Northeast Water Purification Plant (NEWPP)
Improvements Package No. 2 – High Service Pump Station
and Miscellaneous Piping Improvements
WBS No. S-000066-012A-4

ADDENDUM

ADDENDUM NO. 2

Date of Addendum: 11/16/15

NORTHEAST WATER PURIFICATION SYSTEM
PHASE 2 EXPANSION
WTP LIGHTING PLAN

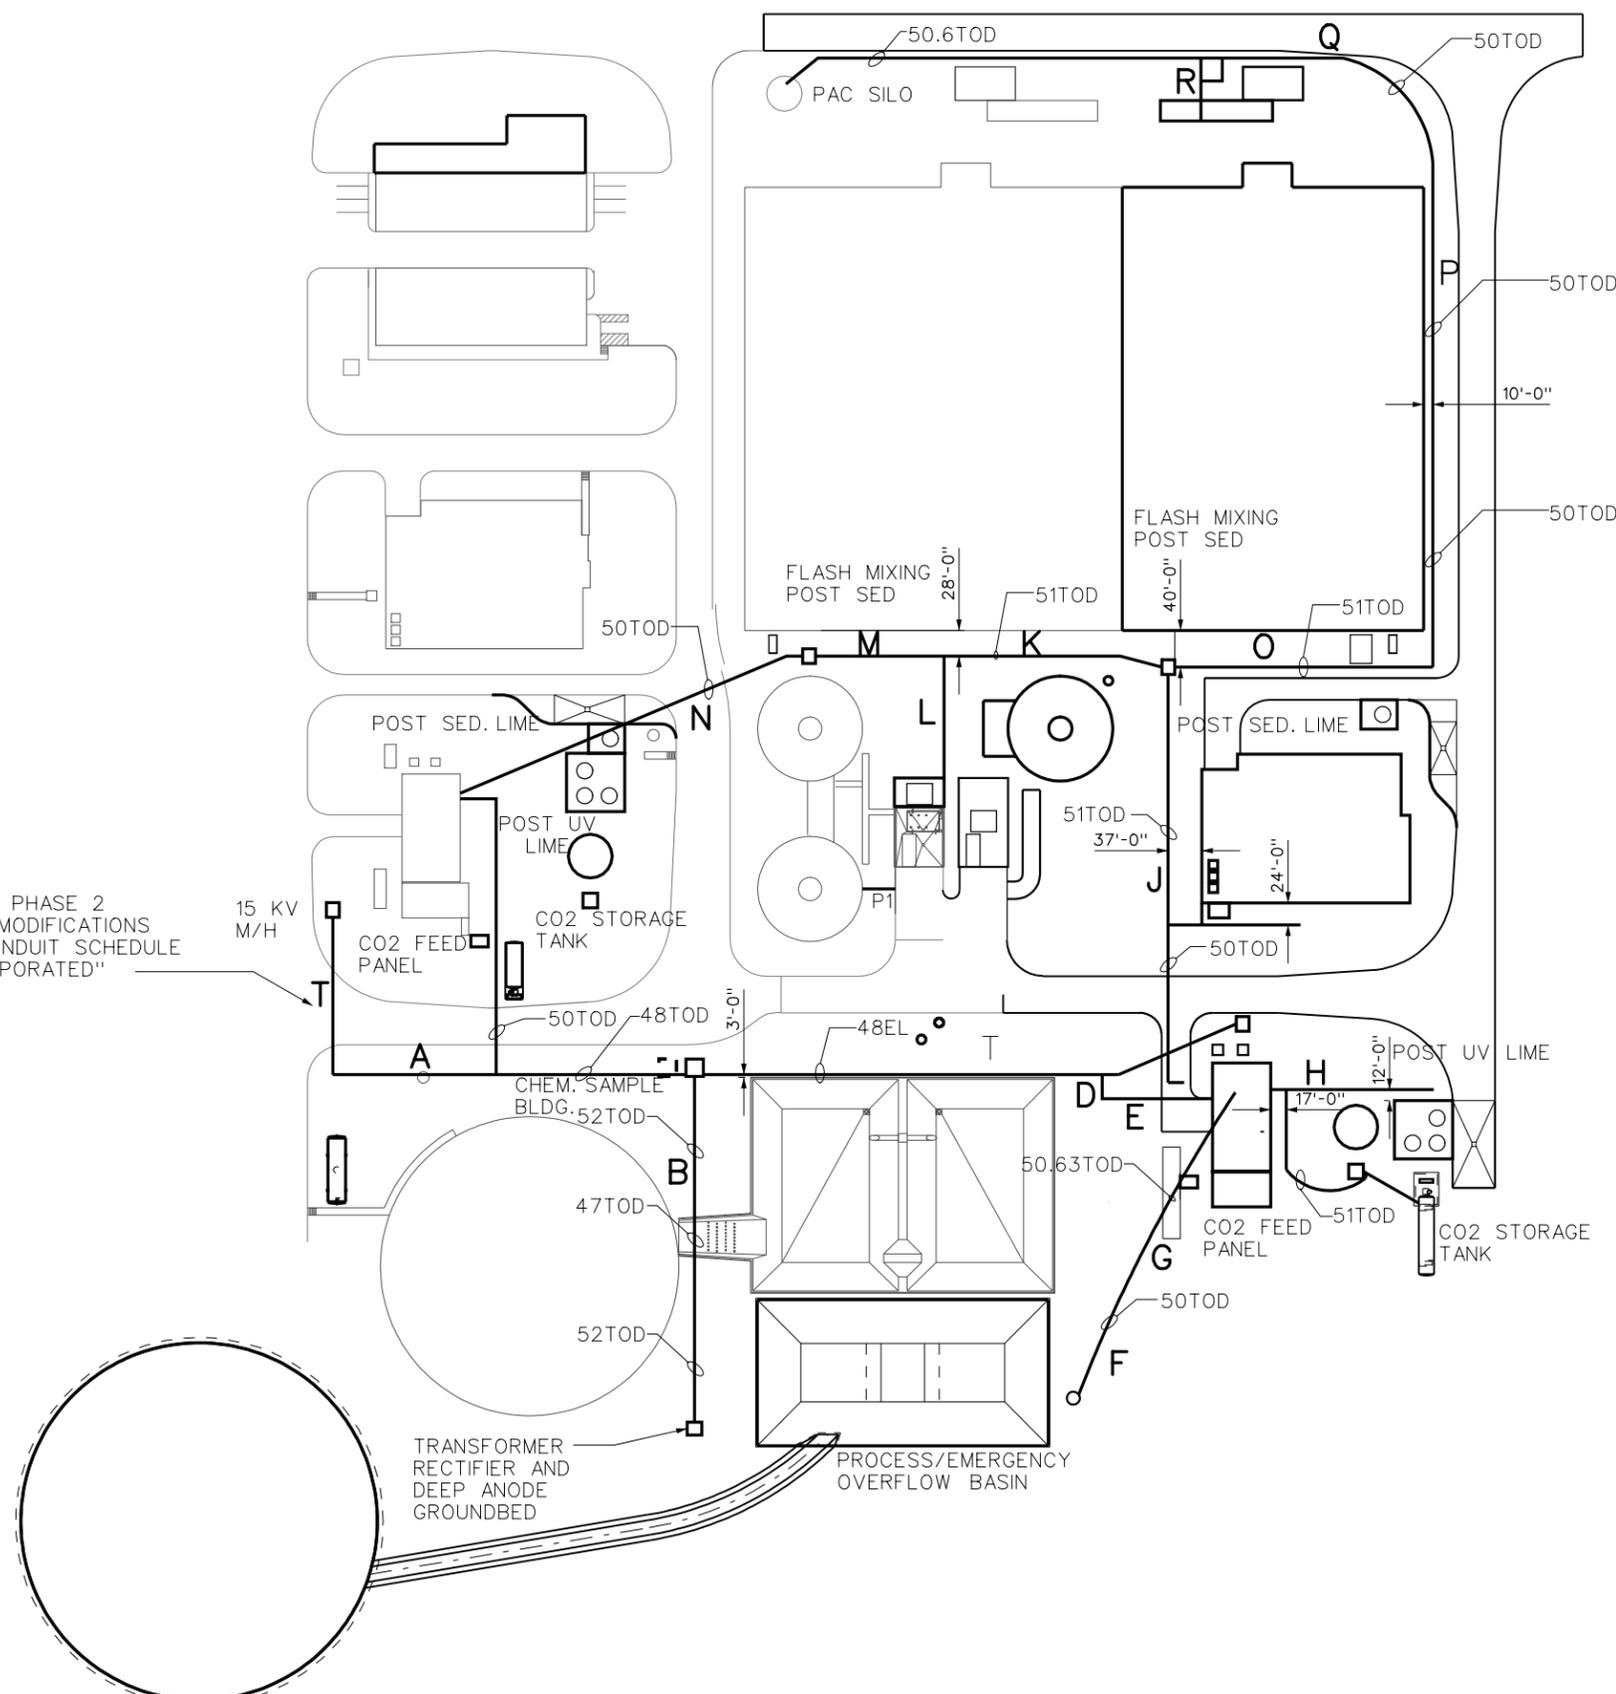
12. Question: Can you please provide electrical As-Built drawings for underground conduits around the areas where we have to make line stops & taps?

Answer: Record Drawings provided by the City illustrating this area are included to the end of this document.

CONSTRUCTION STAGING AREA AND CENTERPOINT WORK SITE PLAN
 ELECTRICAL

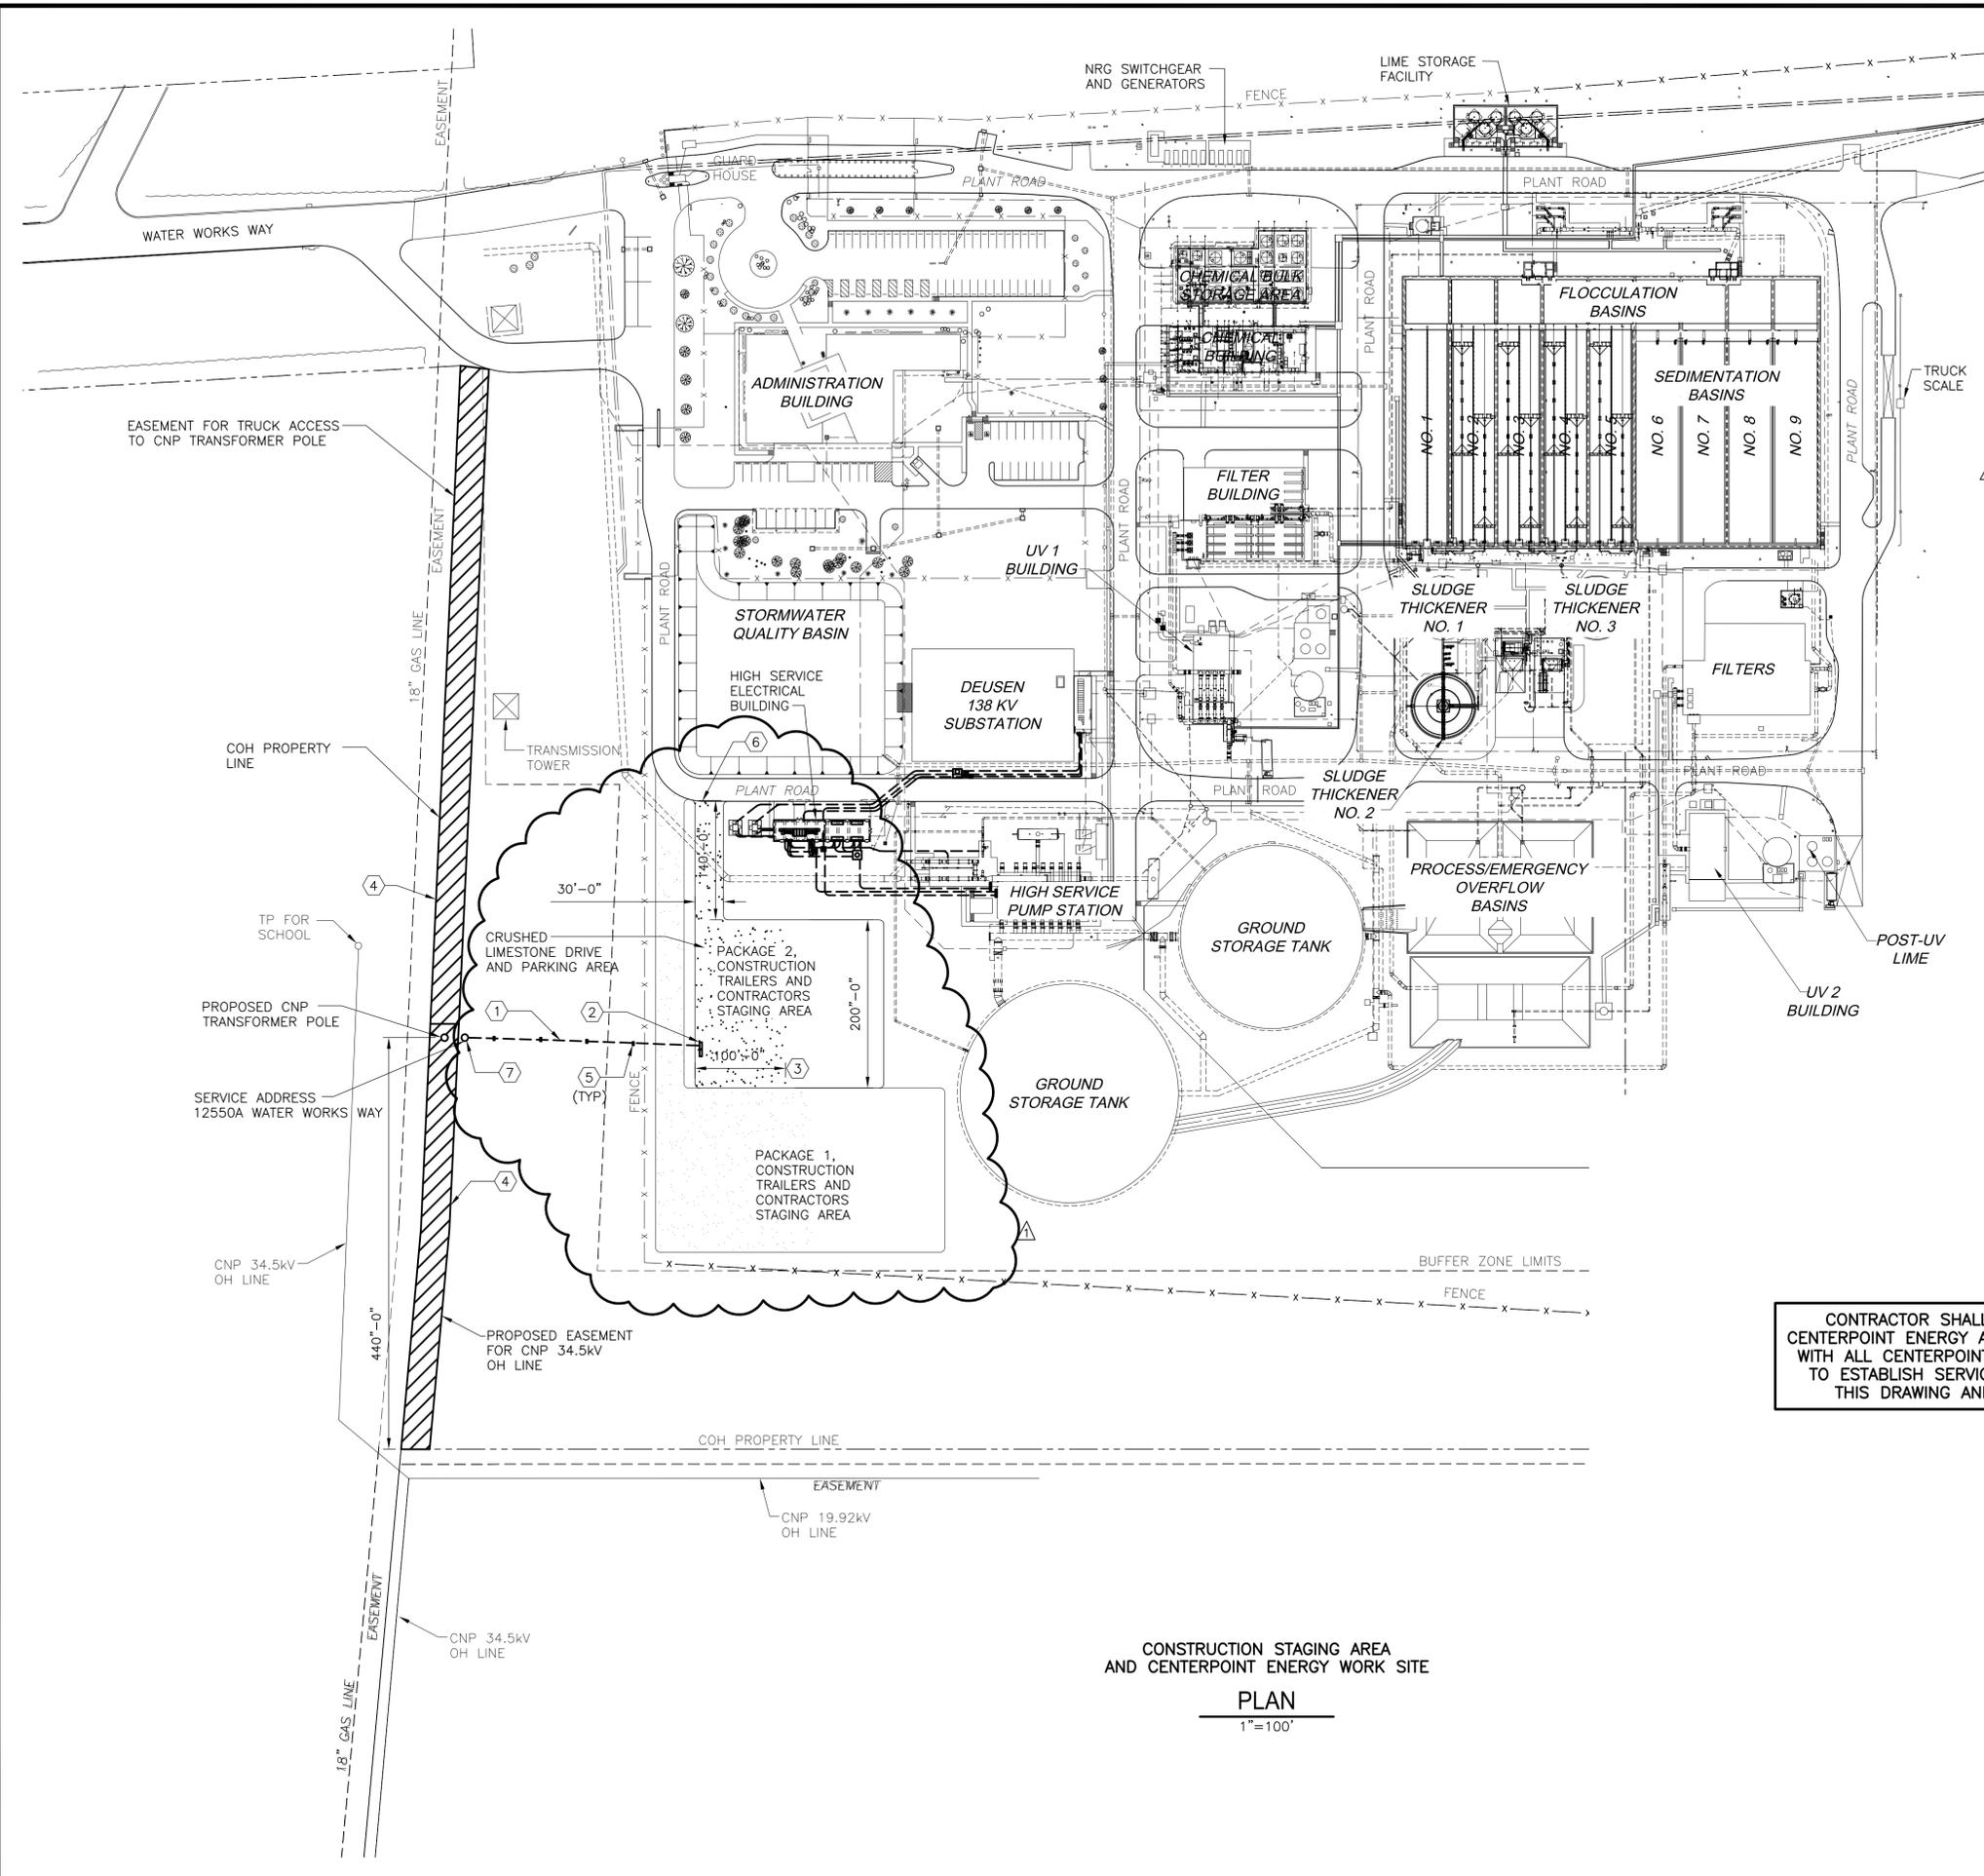
6. Question: Note 4 on sheet E-31 states to include crushed limestone fill or culverts in wet spots along the easement. There is no way for us to know how much fill is needed, or how many and of what size culverts to include. Please tell us specifically what is required or include Extra Work Ptems for this.

8. Question: Note 4 on sheet E-31 states to include crushed limestone for the temporary staging area parking lot & drive. Can this be crushed concrete?

Answer: Drawing E-31 has been revised.

Answer: No, crushed concrete is not acceptable, crushed limestone is required.

- 4 CLEAR A 30' RIGHT-OF-WAY ADJACENT TO PLANT PROPERTY LINE OF ALL TREES AND VEGETATION. GRIND TREE STUMPS FLUSH WITH GRADE. GRADE RIGHT-OF-WAY TO A UNIFORM ELEVATION SO THAT UTILITY COMPANY TRUCKS CAN DRIVE DOWN THE RIGHT-OF-WAY. CENTERPOINT ENERGY WILL SET POWER POLES 7' EAST OF THE PLANT PROPERTY LINE.
